54-289
1149 Regency Dr.
Columbus, Ohio 43220
October 23, 1982

Subject: Review of GPU Nuclear submissions on TMI-1 OTSGs to
NRC, October 18/19, 1982, and of Battelle Columbus
final report to GP Nuclear "Failure Analysis of Inconel
600 Tubes from OTSG A and B of Three Mile Island Unit-1."

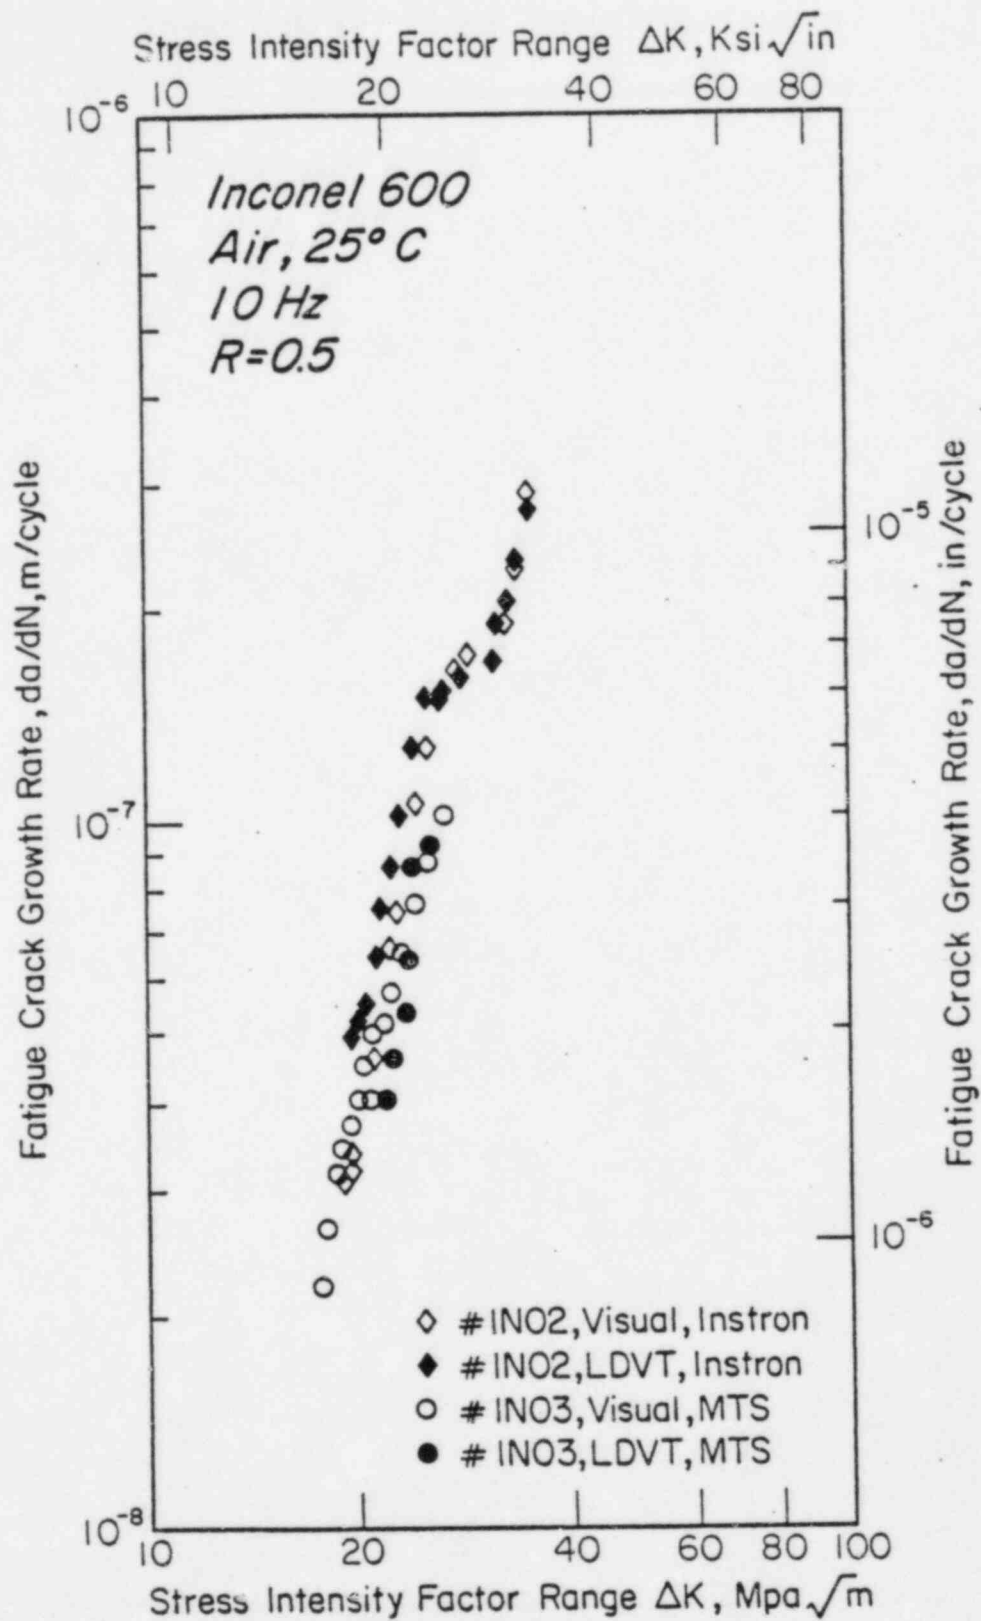
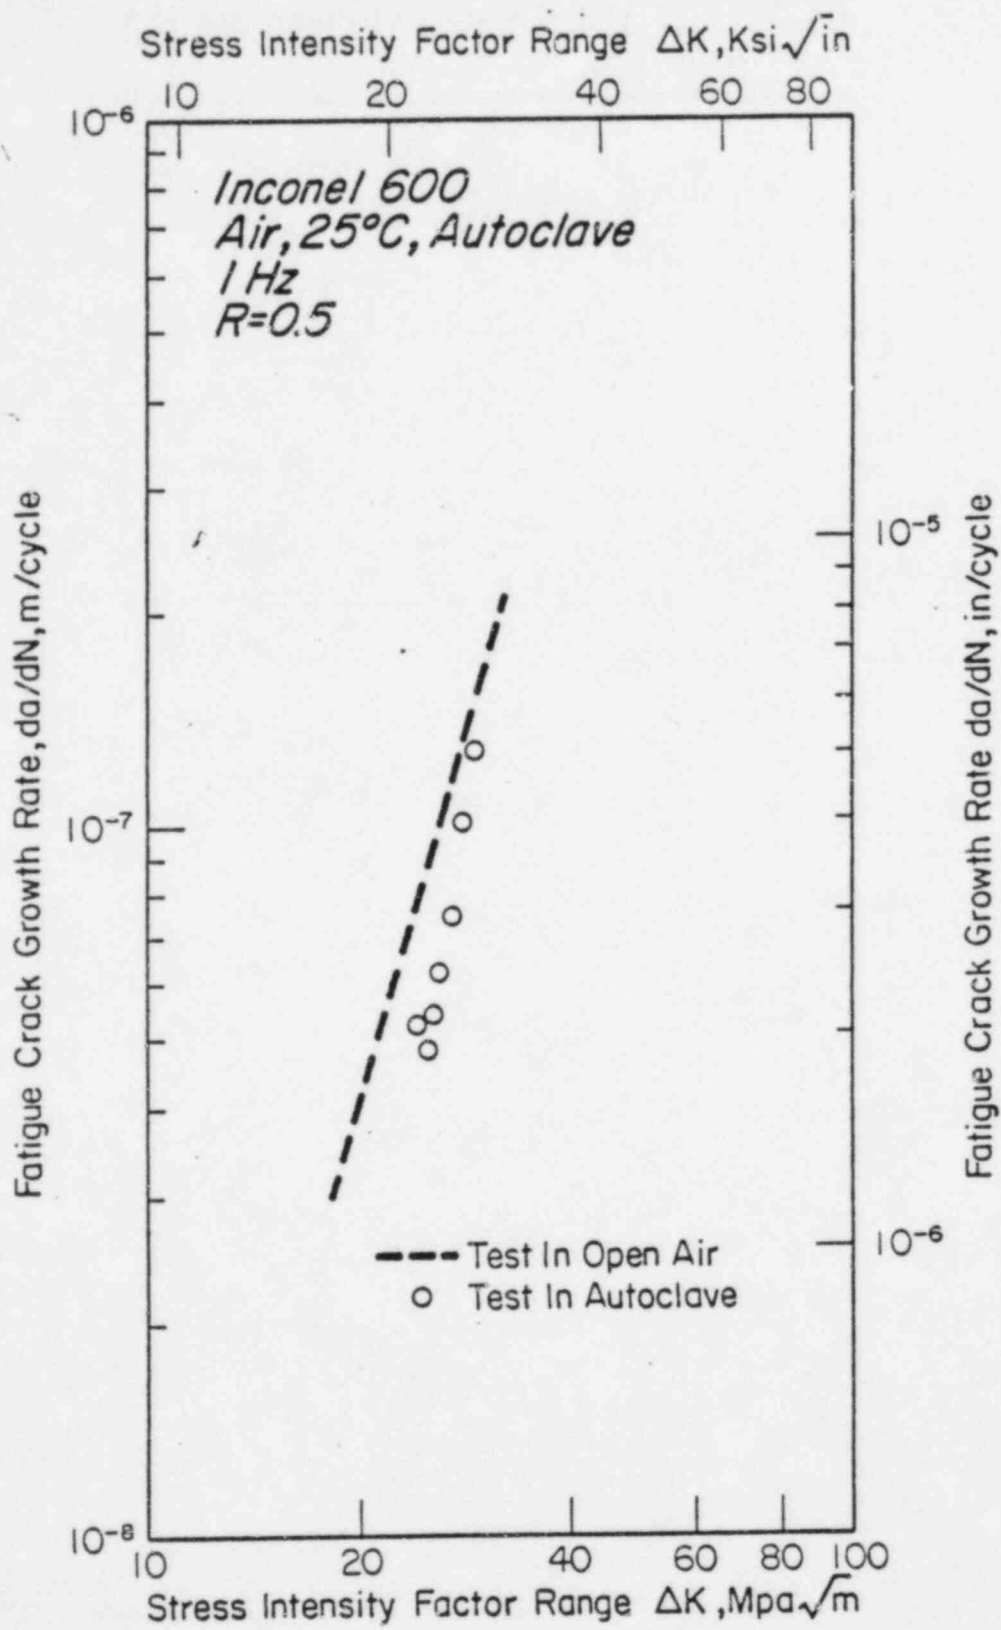
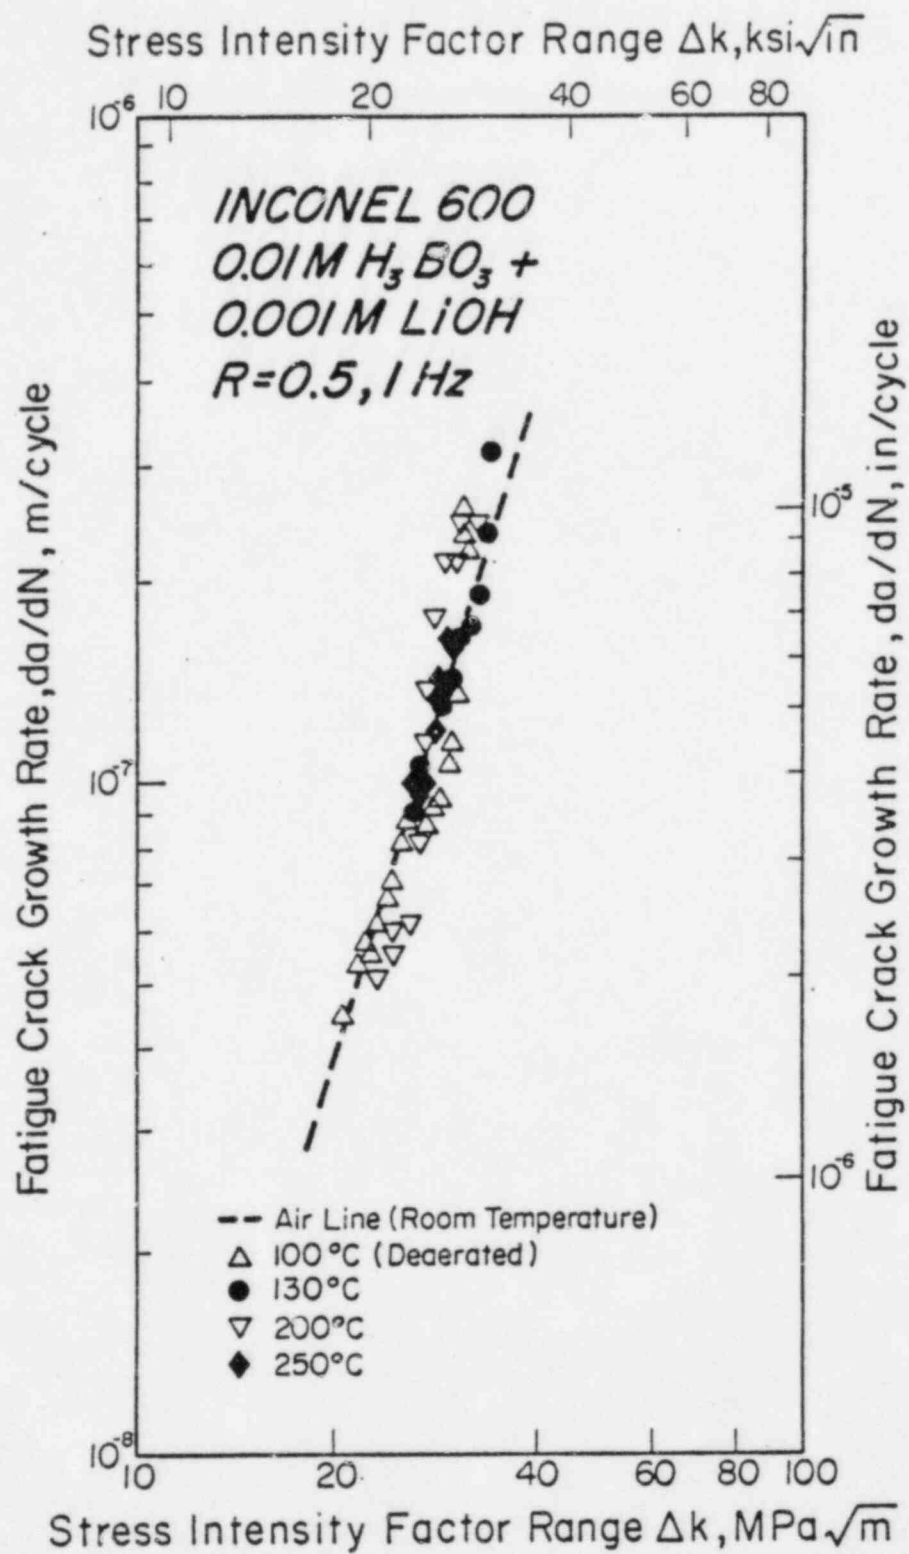
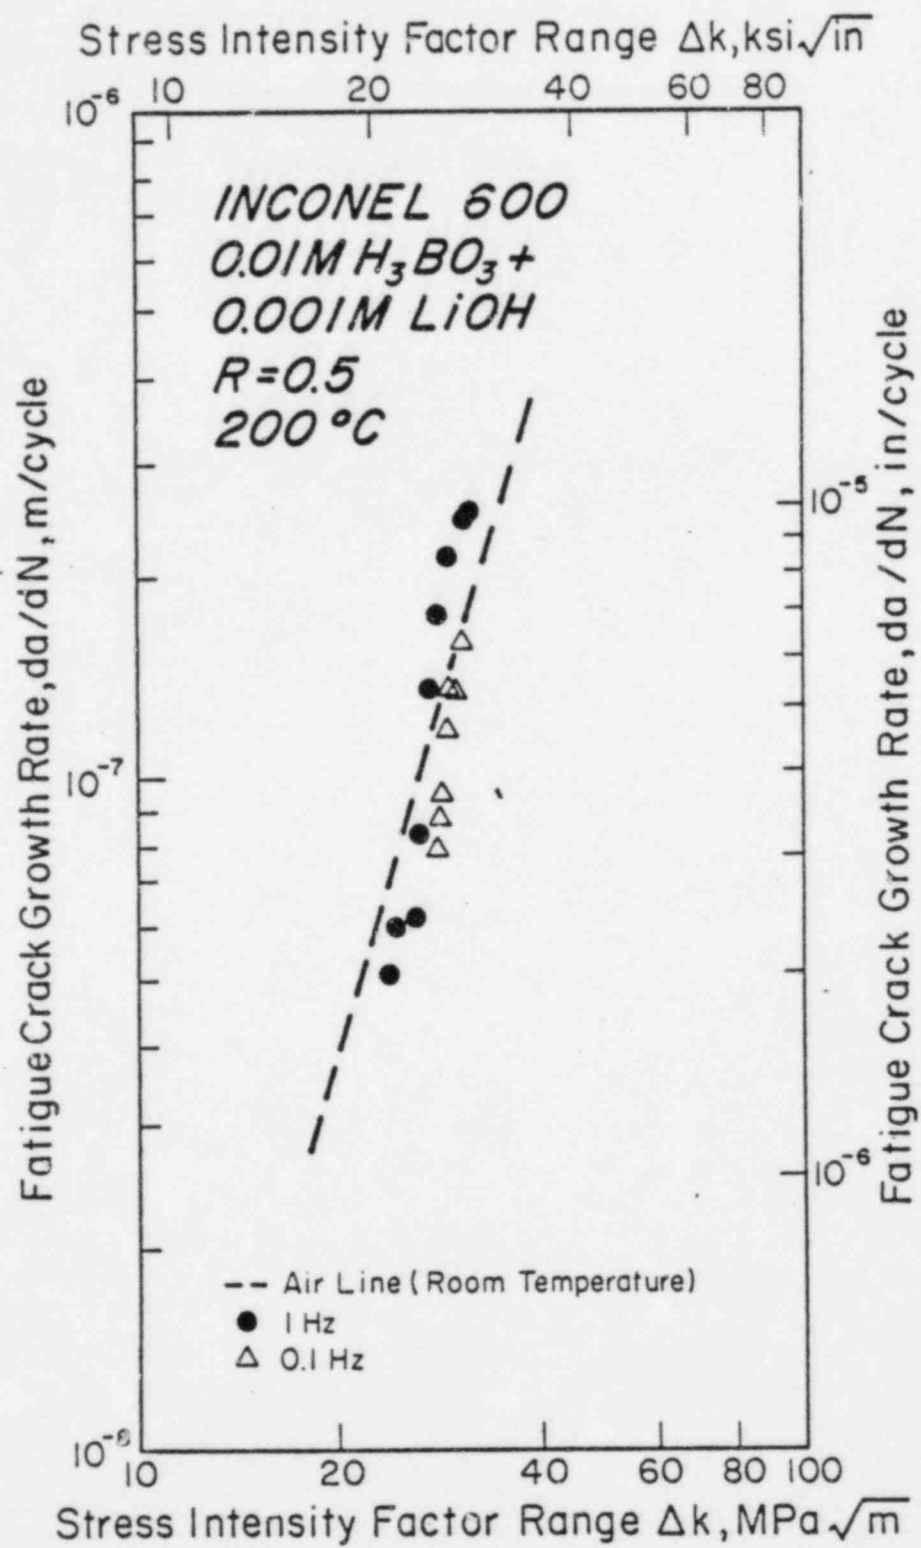
Some other data exist for the propagation of cracks in I-600 in PWR primary environments. Data that have been obtained in this consultant's laboratory by Mr. Wen-ta Tsai (Graduate Student) are shown in Figures 1-5. Although these data were obtained at a more realistic R ratio (0.5) and over a range of frequency (10-0.1 Hz), the measurements were performed on mill-annealed material rather than on the sensitized state that exists in the TMI-1 OTSGs. Comparison of the GPU data with that given in Figures 1-5 shows that the two data sets are in reasonable agreement, which supports the contention that the MIT data may not refer to the metallurgical condition of the TMI OTSG I-600 tubes. Clearly, the data base used by GPU Nuclear requires further critical evaluation before the crack growth calculations can be taken as representative of what might be observed in the steam generators during operation. I recommend that the GPU calculations be repeated with "worst case" estimates for the crack propagation rate--possibly those for Type 304SS would be appropriate. Data for
